DATE: **Apr.28/03****V2500-A1/A5/D5 SERIES PROPULSION SYSTEM SERVICE BULLETIN**

This document transmits the Initial Issue of Service Bulletin EV2500-72-0455

ENGINE – PROVIDE NEW ADAPTER AND TUBE FOR DIFFUSER 10TH STAGE POSITIONS 72 AND 288 DEGREES

Figure 1

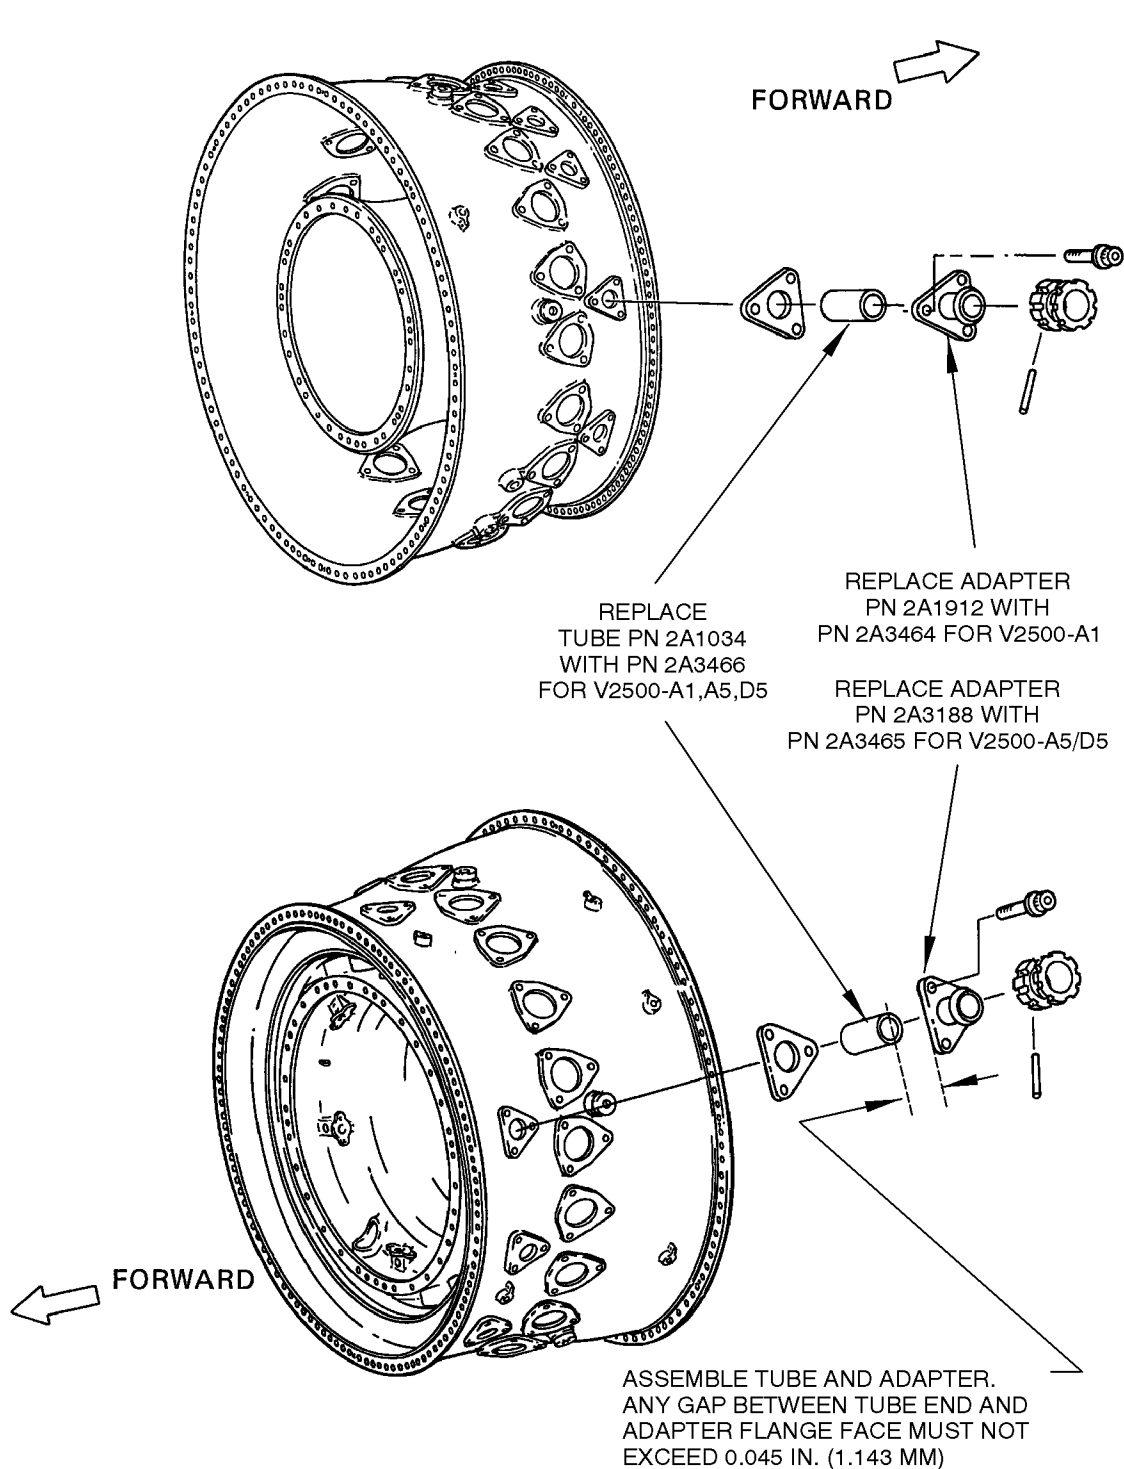
(a) Replace Tube PN 2A1034 with PN 2A3466, see Figure 1.

(b) Replace Adapter PN 2A1912 with PN 2A3464, see Figure 1.

(a) Replace Tube PN 2A1034 with PN 2A3466, see Figure 1

(b) Replace Adapter PN 2A3188 with PN 2A3465, see Figure 1.

(c) After assembling the Adapter and Tube check for space between the adapter flange and the tube. This distance may not exceed 0.045 (1.143 mm).

(c) After assembling the Adapter and Tube check for space between the adapter flange and the tube. This distance may not exceed 0.045 (1.143 mm).
